3D Model Space Clashes

8th May 2024

3D model uploaded to EDMS

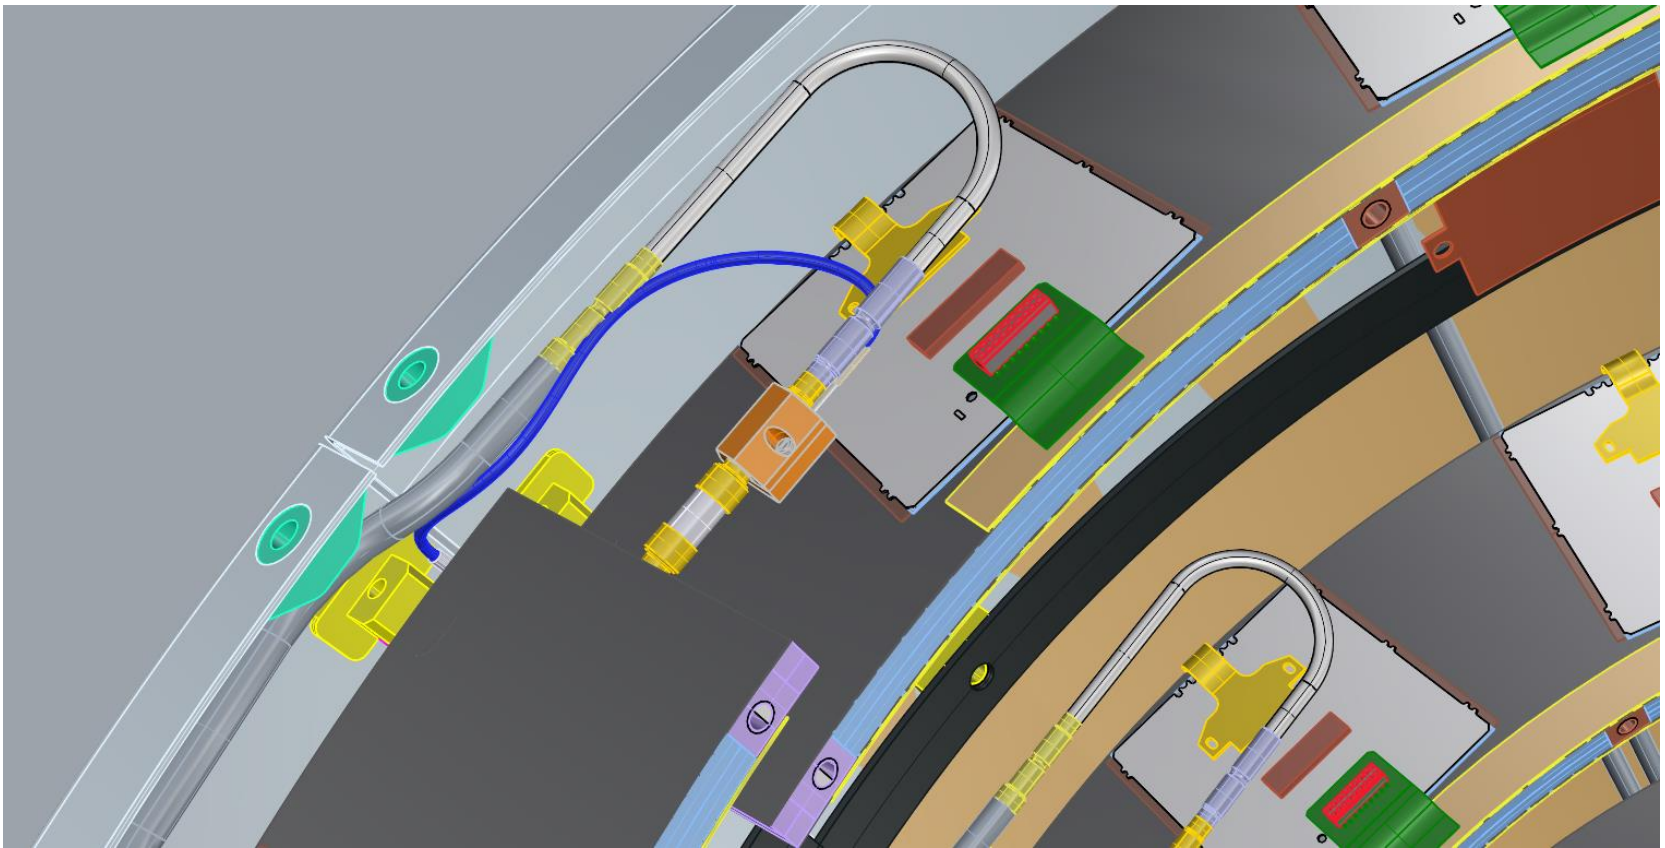
- 3D model of DataPP0 out of date – see connector position mis-match
- Many space clashes
 - No attempt to resolve – no time since Edinburgh
- If anything – situation has got worse as component models are refined and additional parts added – eg Environmental Sensors
- Still missing many parts – eg there are no clamps/fixations for the Type-1 cooling services.

Cooling System Temperature Sensors (Ring 1)

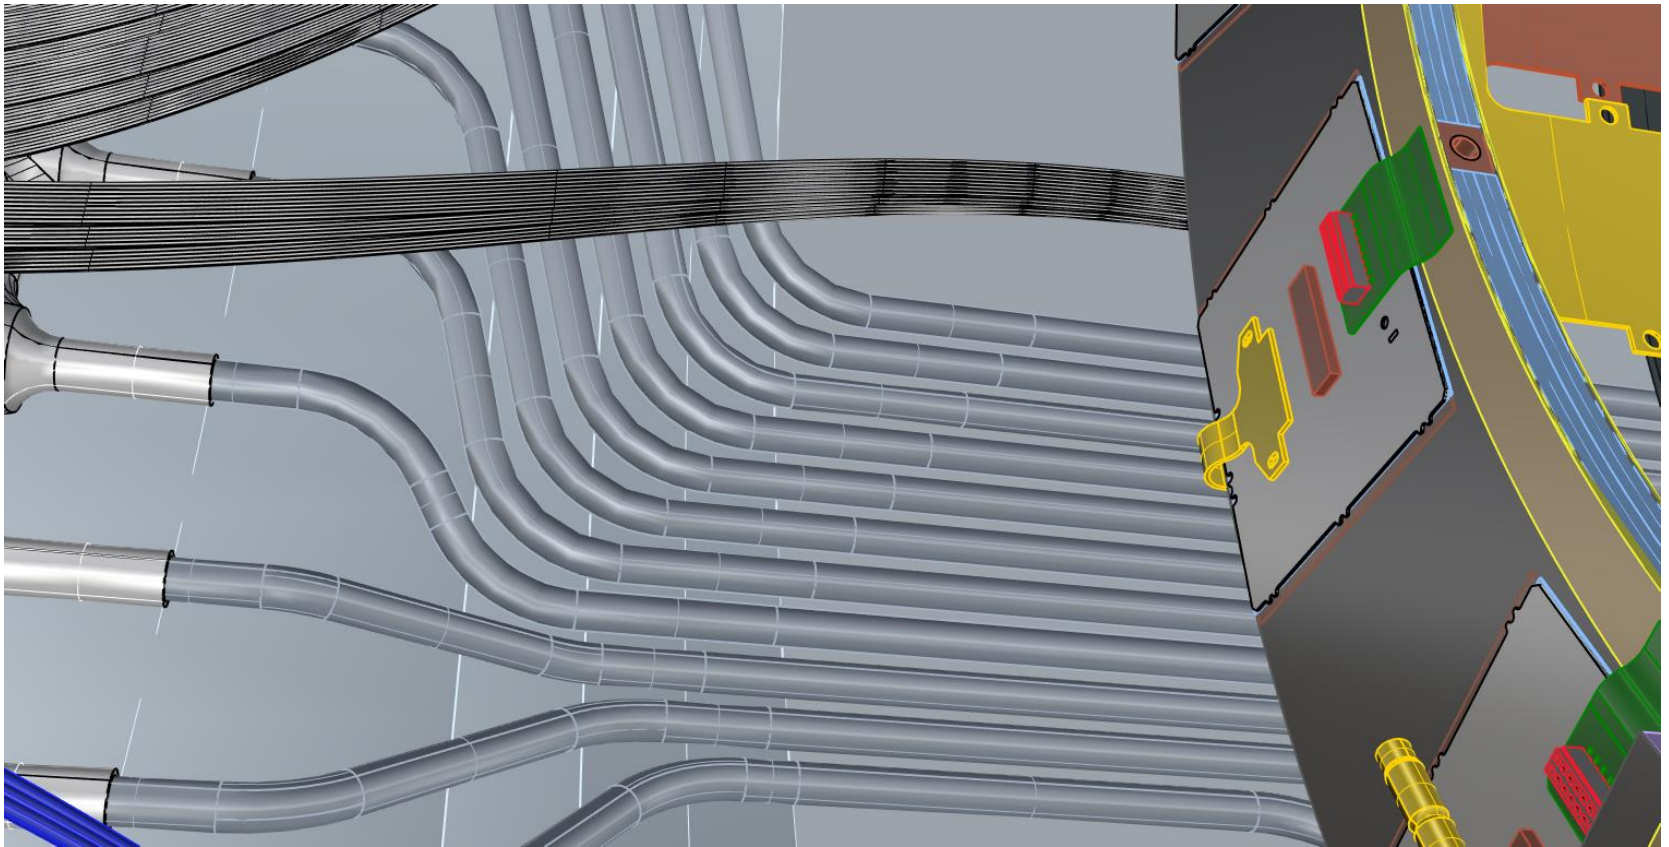
When there are added the Front Support is not blocking access – but we've always assumed access to all fixings (eg half-ring mounting screws, Data PP0s, Power connectors are on the high Z side (except for last HR). Does the HC integration tooling permit access ?

Clash between DataPP0 finger and Type-1 Cooling Exhaust – HR11

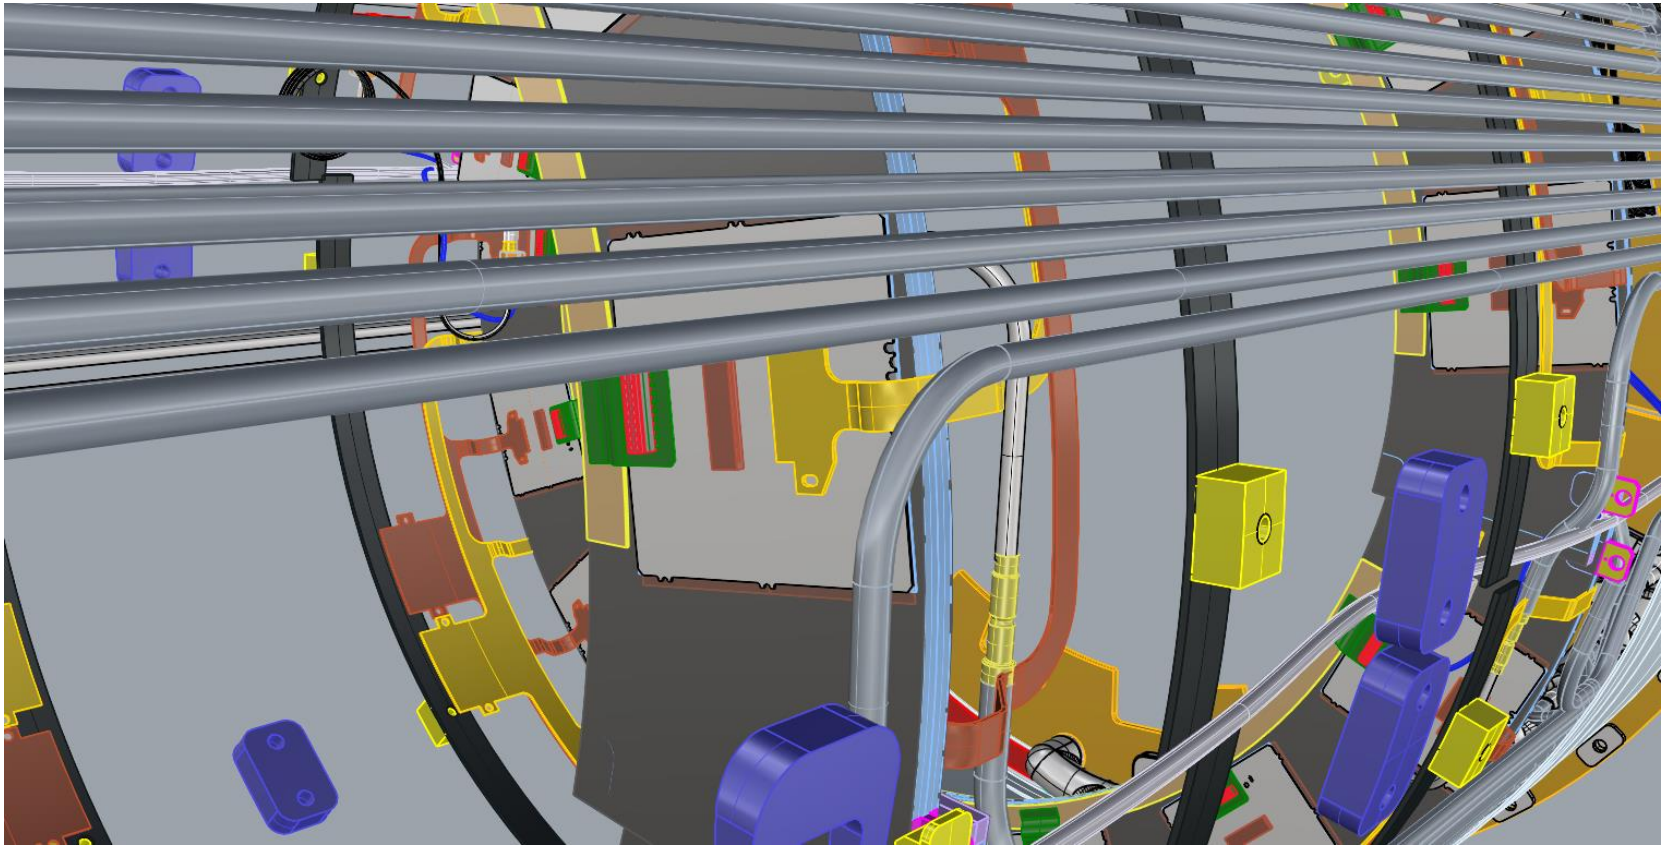
I have a DataPP0 here – I do not believe the bends assumed in the 3D modelling are realistic – unless there is a ‘feature’ on the outer rim of the half-ring to fix the DataPP0 finger to. Suggest moving group of 4 exhaust tubes round in phi.

Type-1 Cooling Inlet – many clashes

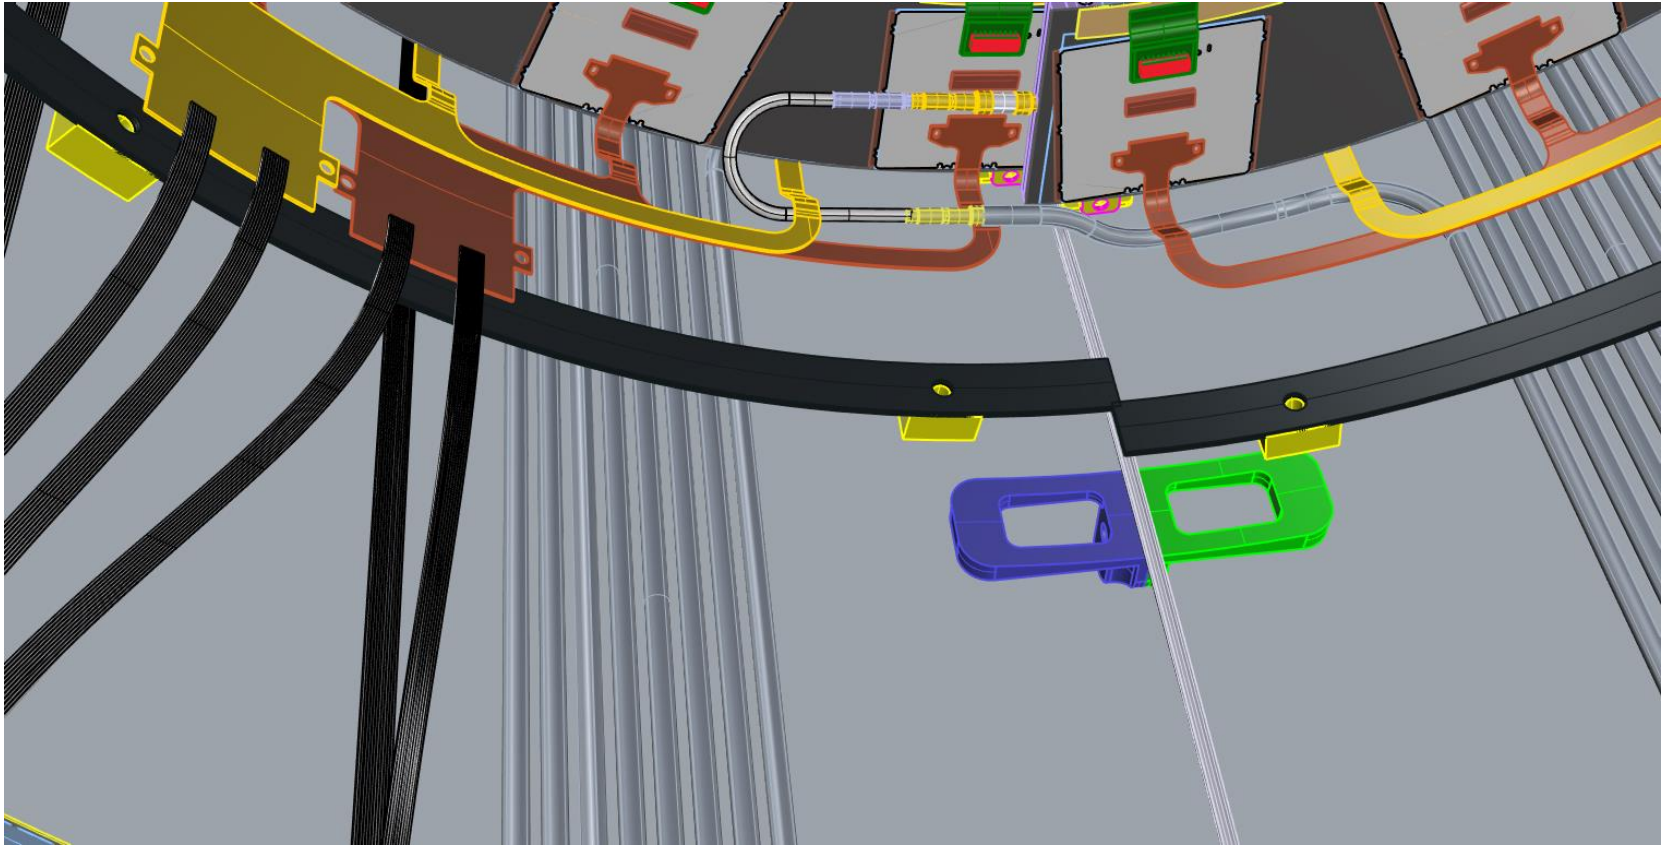
Identified & discussed at Edinburgh but no time to fix due to preparations for FDR. Plan is to investigate turning capillary coils through 90 degrees – might also help with clashes during HC joining.

Half-cylinder joining – Inlet side

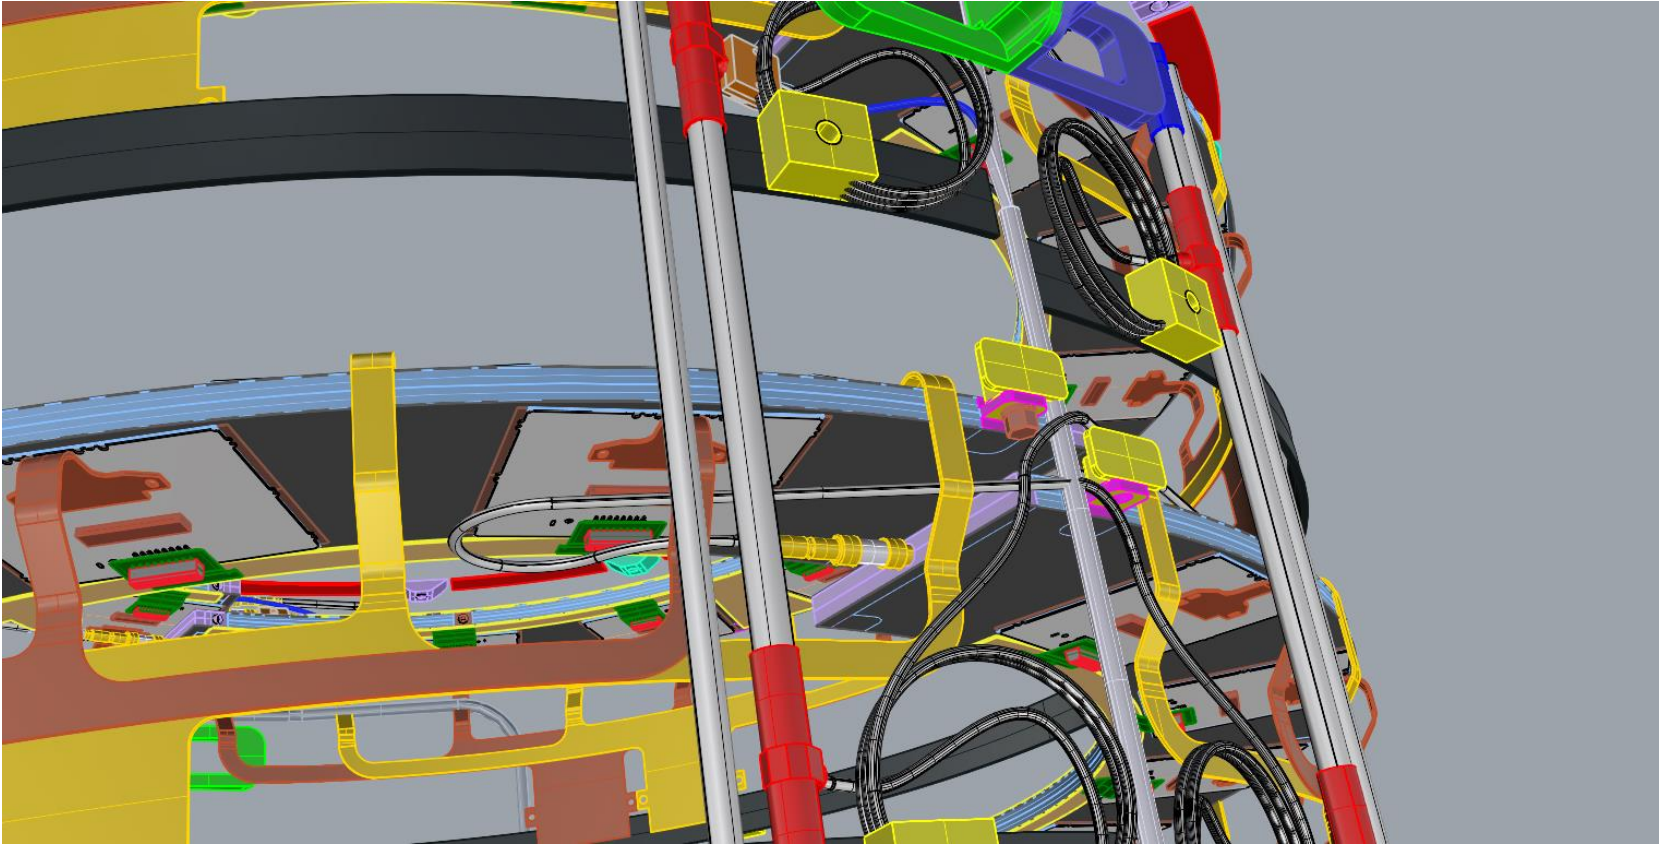
Long length of capillary loop penetrates into opposite side – what keeps it in place ?
